CERTIFICATE OF APPROPRIATENESS PLACARD

515 N BLOUNT STREET

LEWIS-SMITH HOUSE

PERMIT REVIEW COMMENTS / HISTORIC DISTRICT (TANIA TULLY 3/25/2014):

Gravelpave²

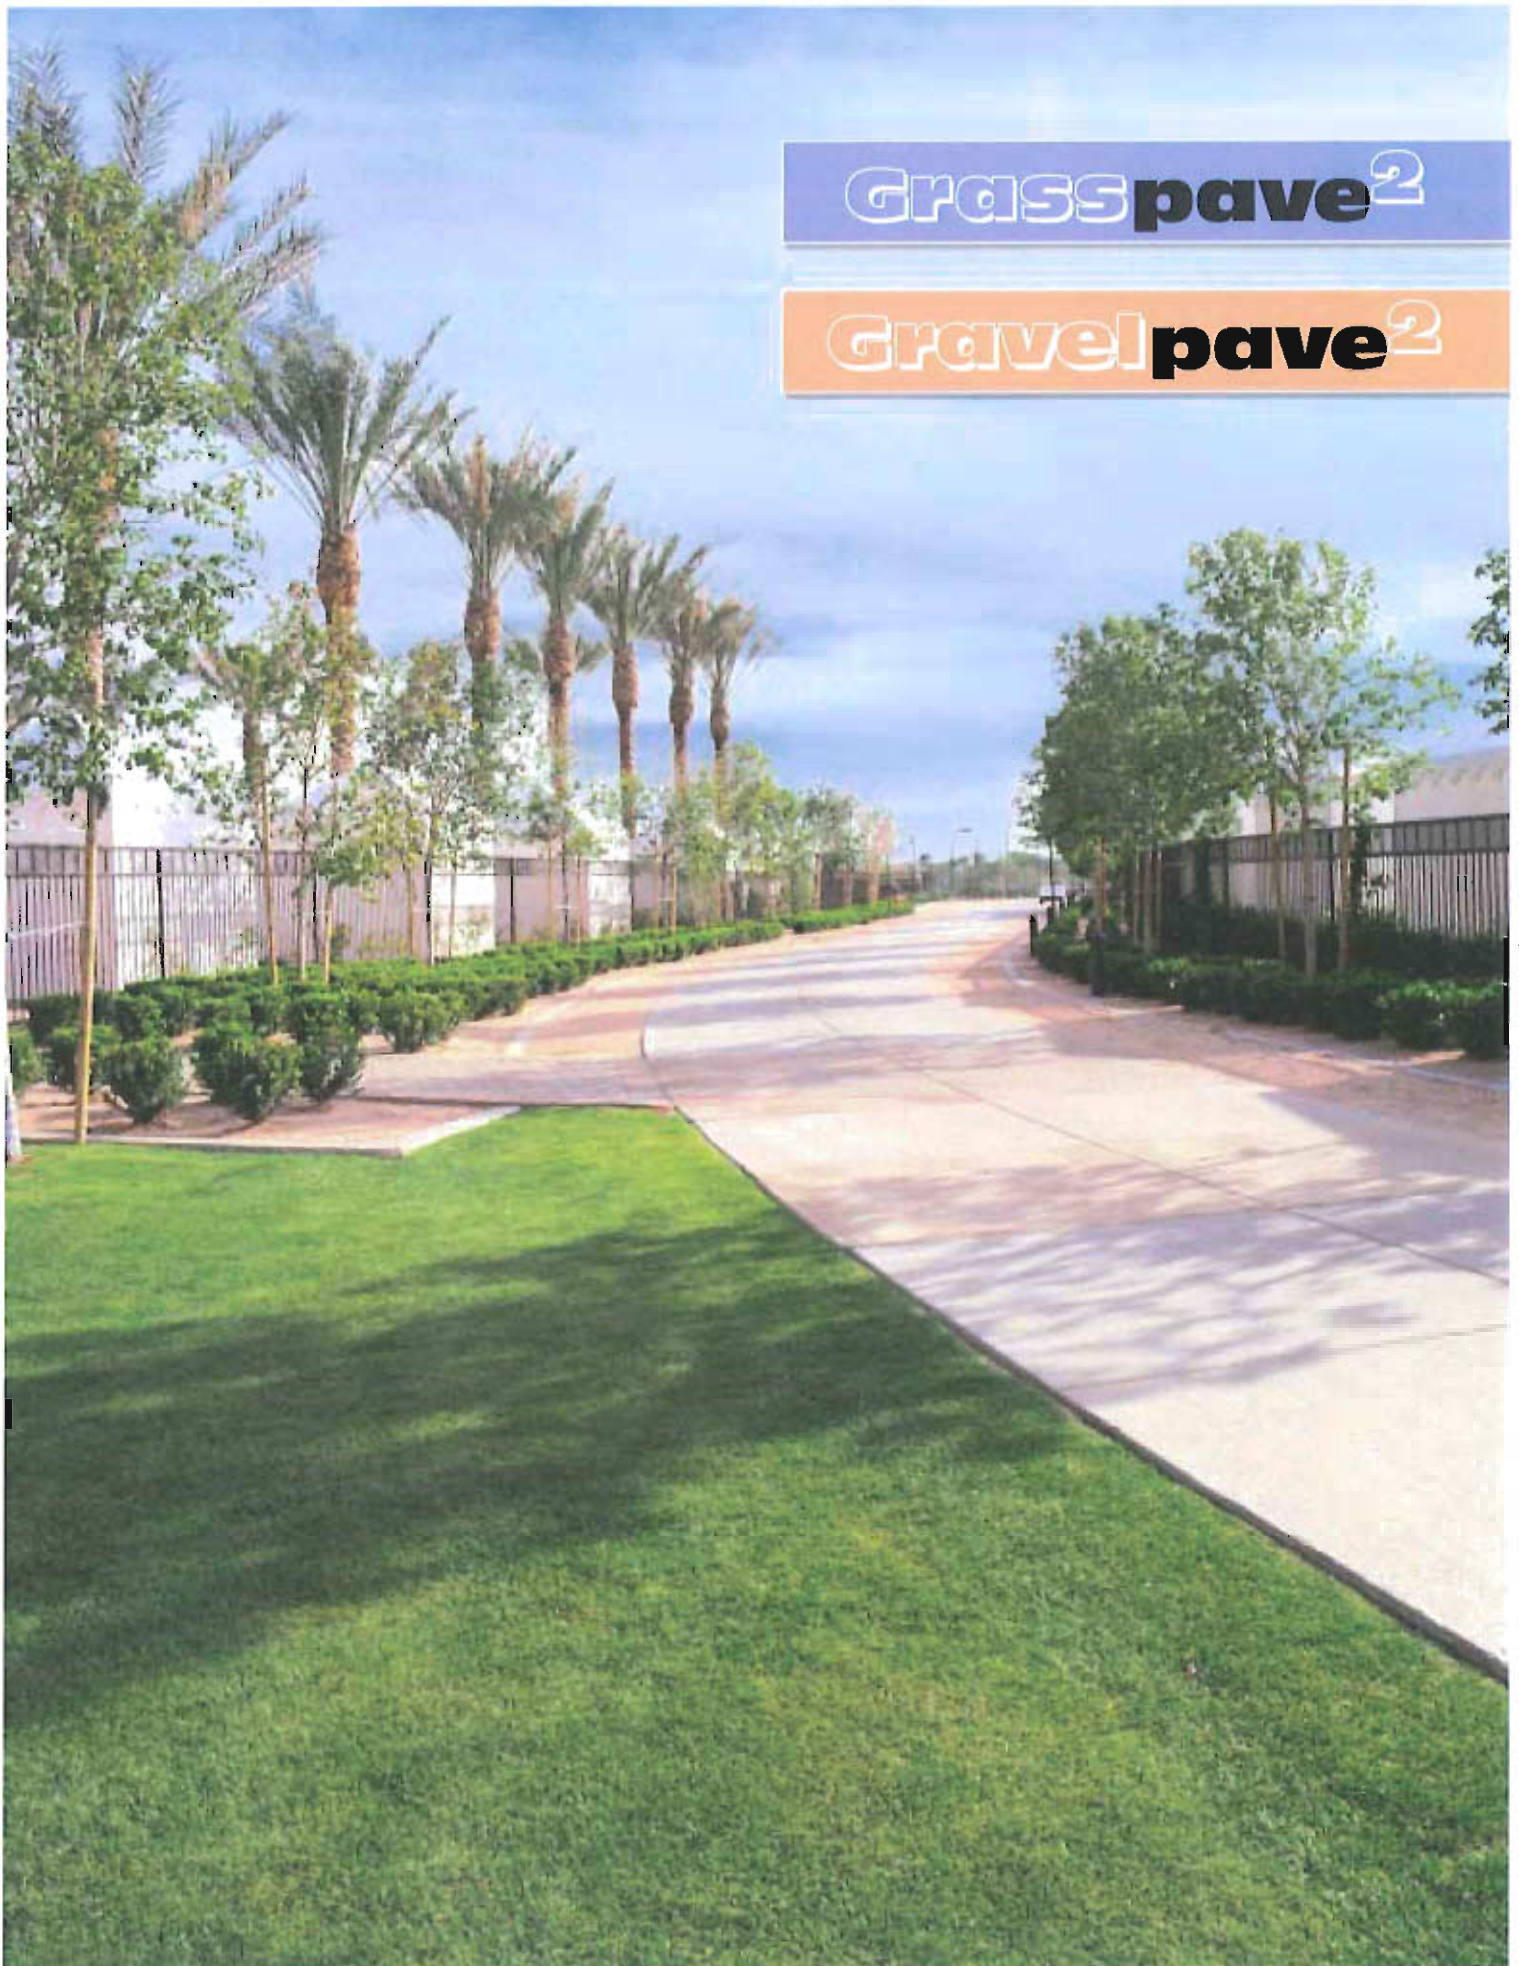
- Front yard parking space and sidewalk (front yard parking space approved in gravel per COA 039-12-MW)
- ↳ New Sidewalk
- RESPONSE : The proposed front yard parking space and access aisle is rendered in porous pavement gravel pavers to address accessibility requirements and maintain the historic appearance of the original gravel drive. Product details and specifications are attached for review and comments.

SHEET NO.
A202

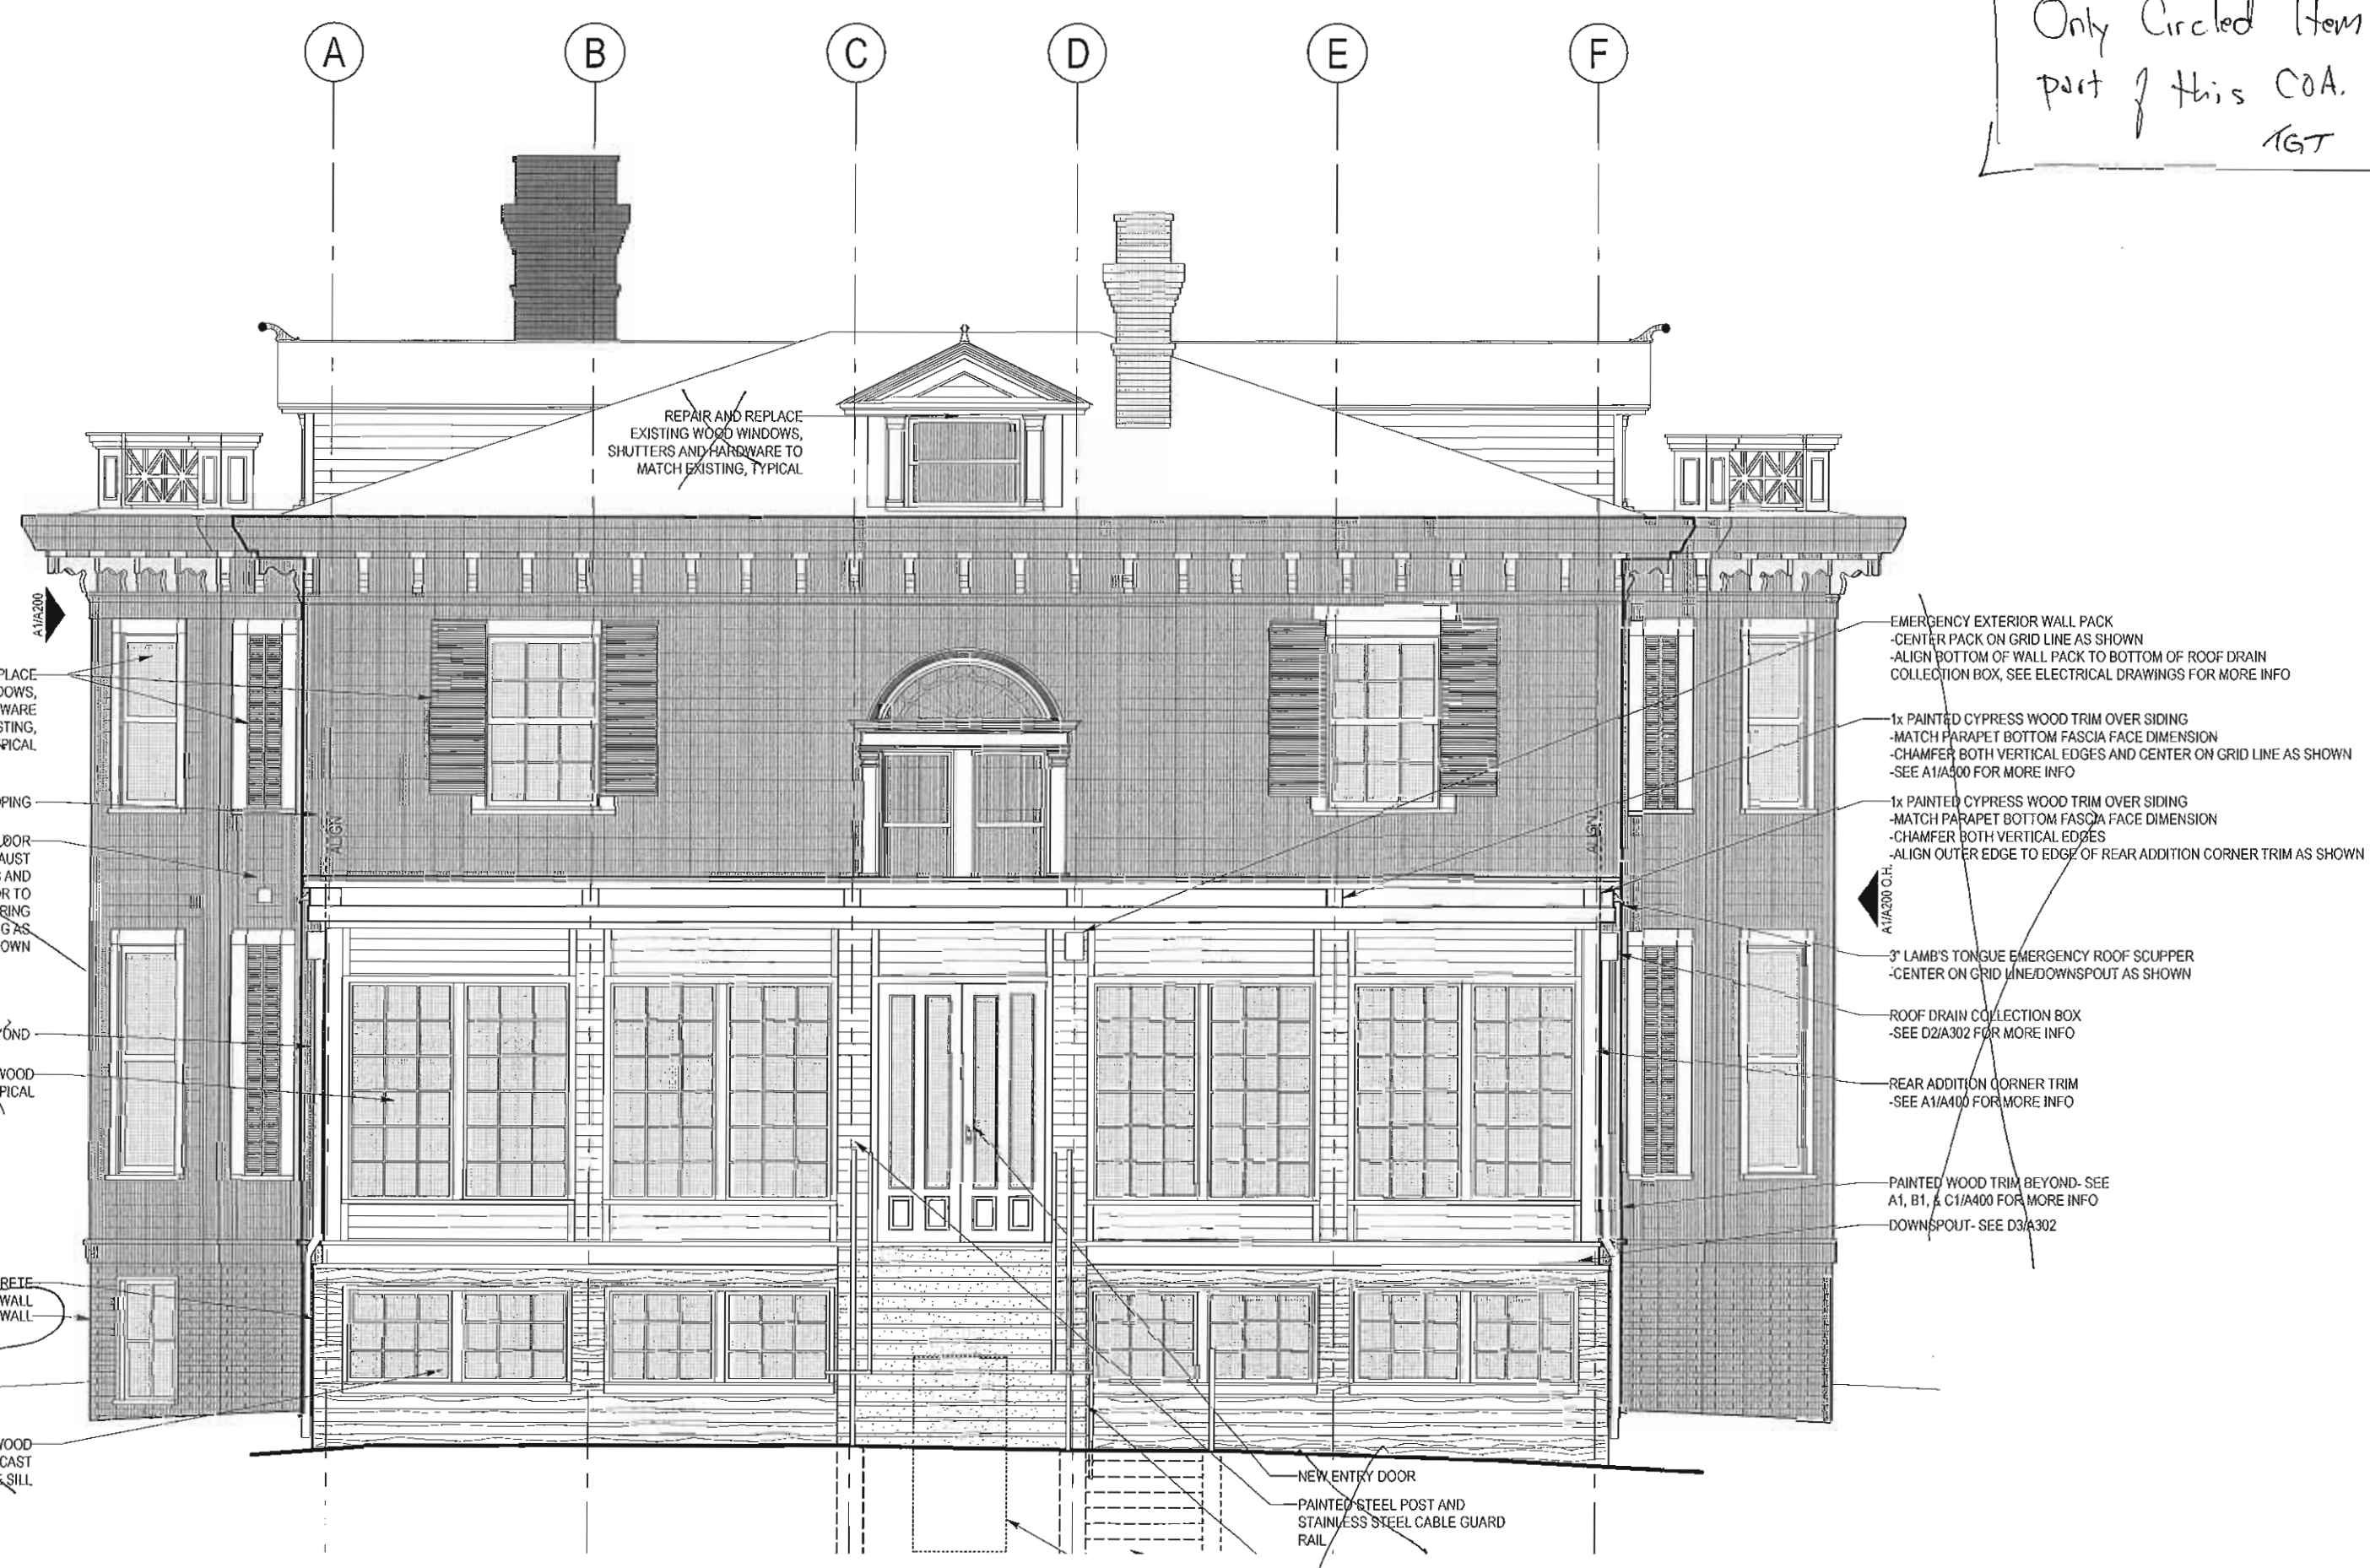
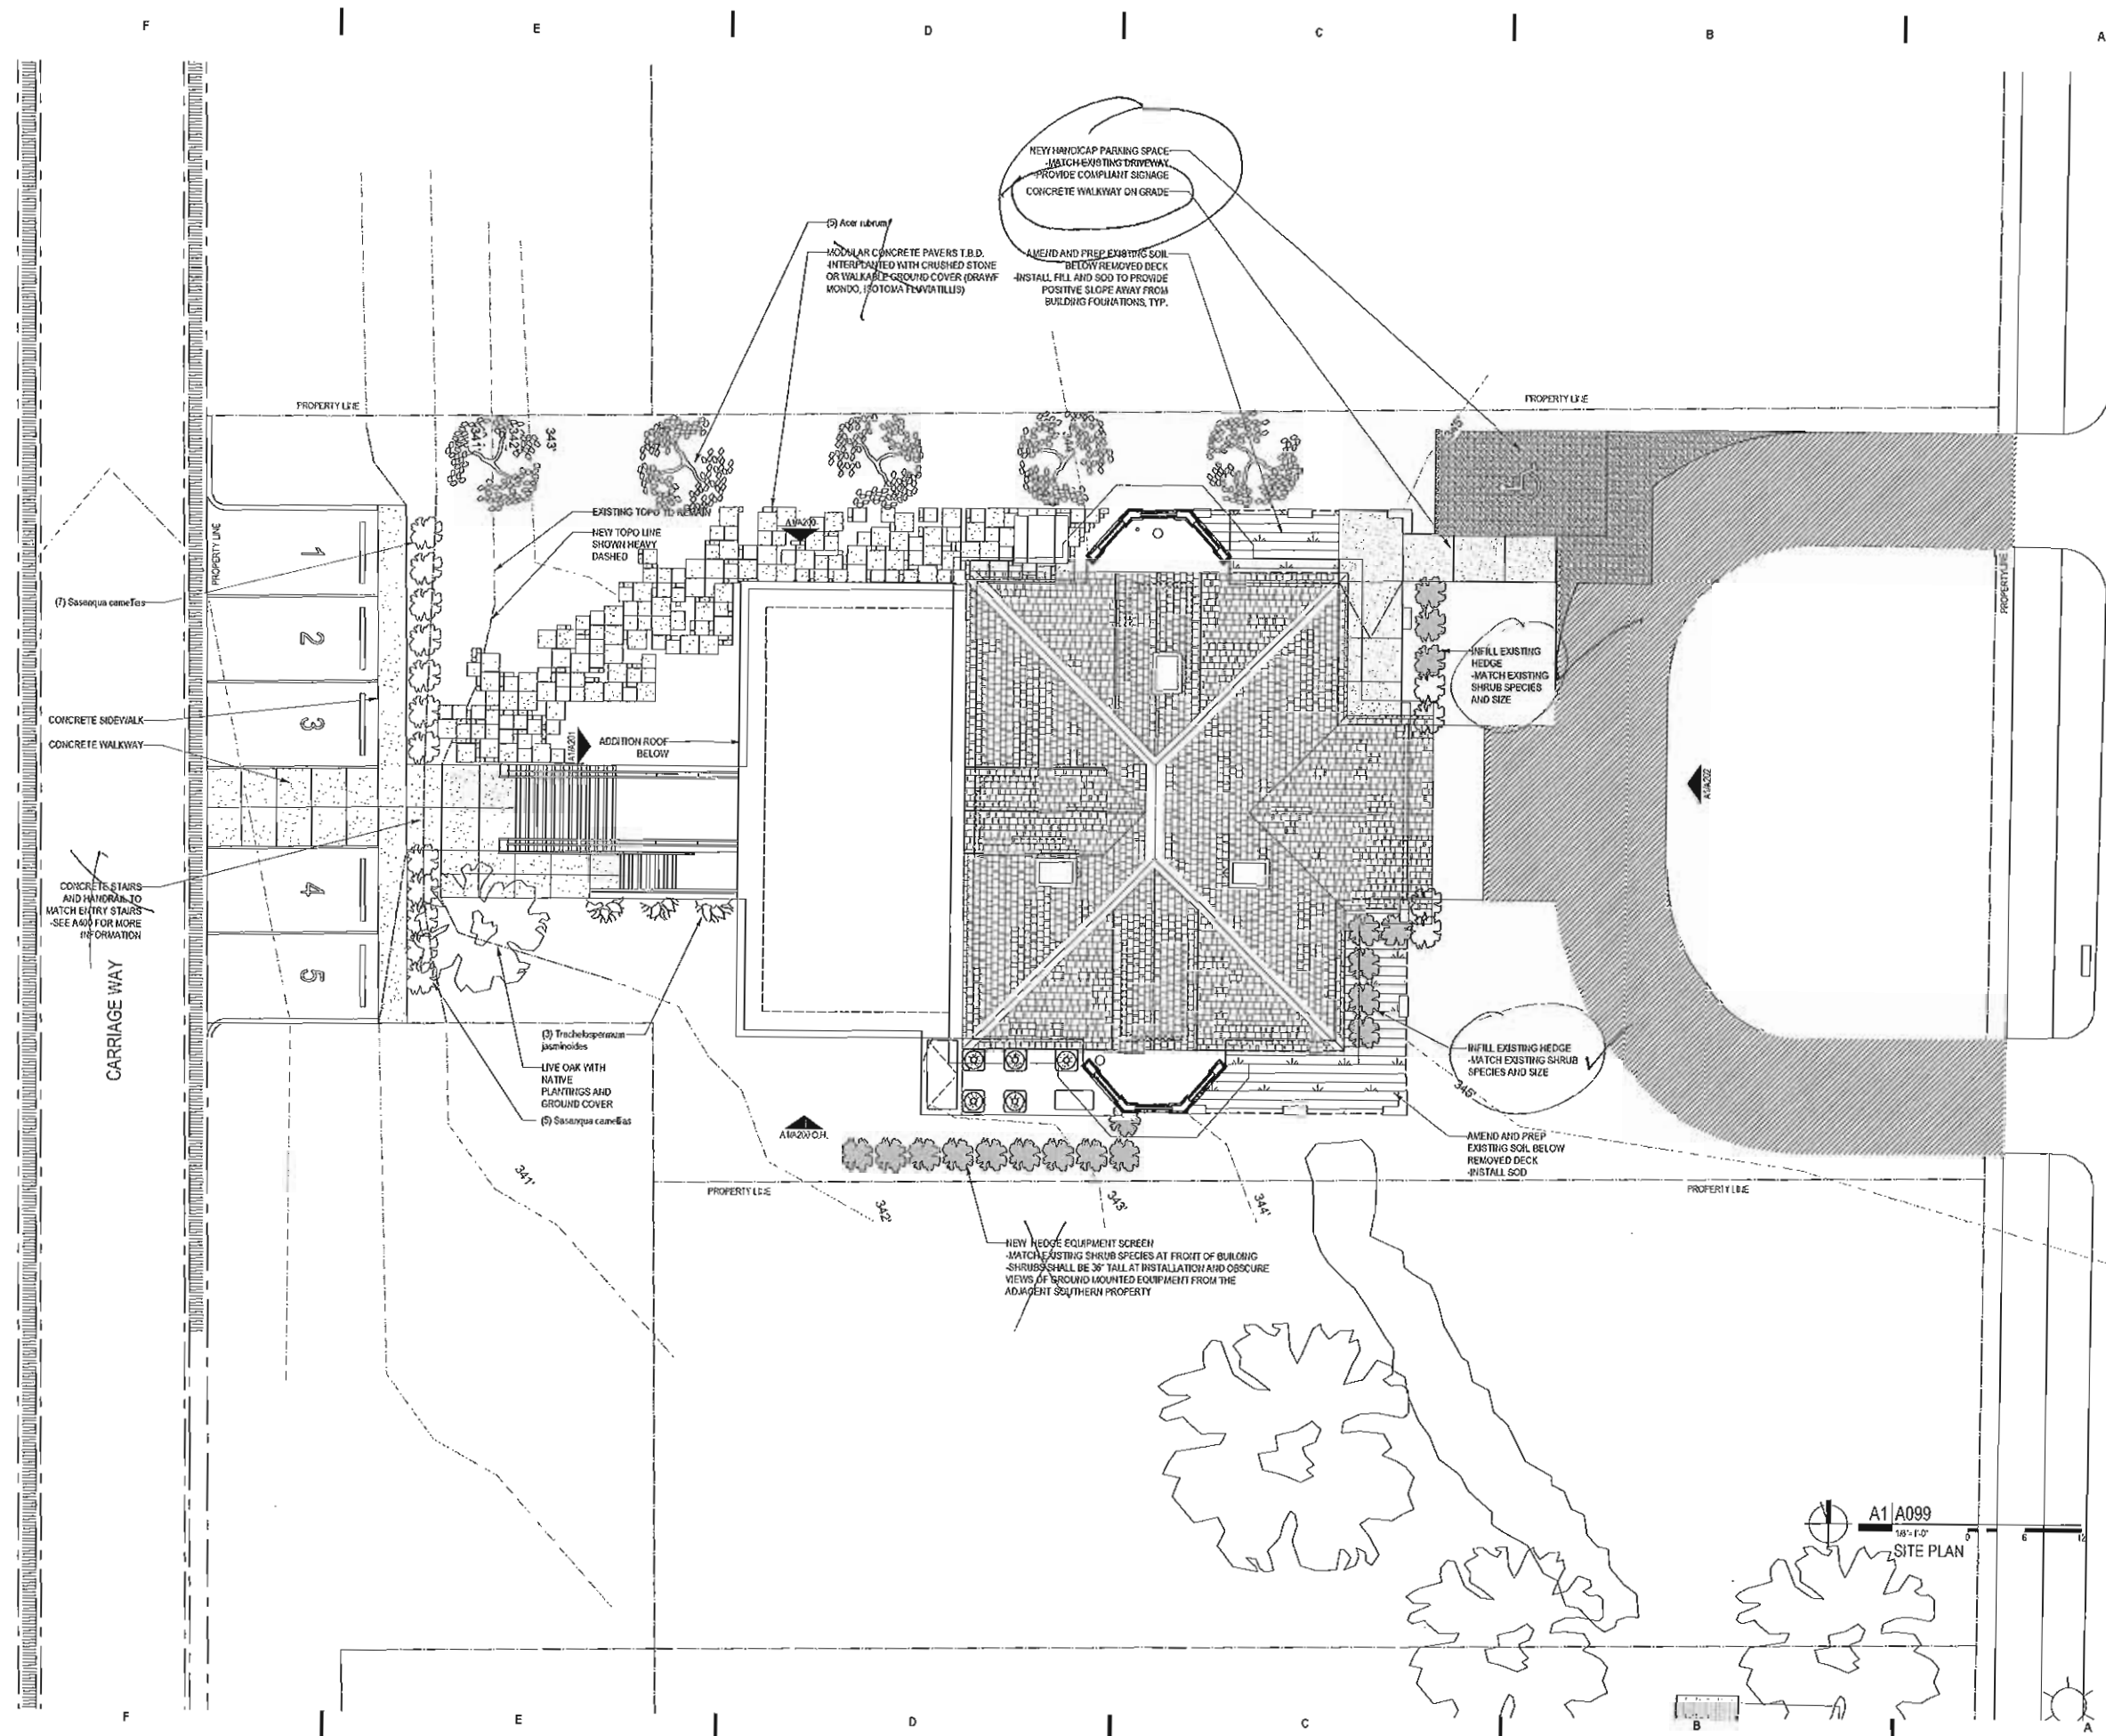
- New railing on front porch (should match height of 2nd level railing)
- RESPONSE : A new railing on the front porch at the 1st level will be installed to match the existing guard rail at the 2nd level balcony in height, profiles, and materials. A single higher rail at 42" above the finish floor level will also be provided to meet code requirements. The high rail will match materials and profiles of the historic top rail of the 2nd level balcony. See sheet A200 & A202.

Only Circled Items
part of this CoA.
IGT.

NEW WOOD GUARD RAIL TO
MATCH EXISTING AT SECOND
FLOOR BALCONY
-MATCH ALL PROFILES,
SPACING, DIMENSIONS AND
MATERIAL AND MATCH TOP OF
EXISTING RAIL HEIGHT TO
COMPLY WITH HISTORIC
PRESERVATION
REQUIREMENTS
-PROVIDE A SINGLE,
INDEPENDENT HORIZONTAL
RAIL WITH TOP OF RAIL SET AT
42" A.F.F., ABOVE THE NEW
MATCHING GUARD RAIL, TO
COMPLY WITH CODE
REQUIREMENTS.
-PROVIDE CODE COMPLAINT
GATES AND ENCLOSURES FOR
PLATFORM LIFT AS REQUIRED
-PROVIDE SHOP DRAWINGS
FOR ARCHITECTURAL REVIEW

VERTICAL PLATFORM LIFT
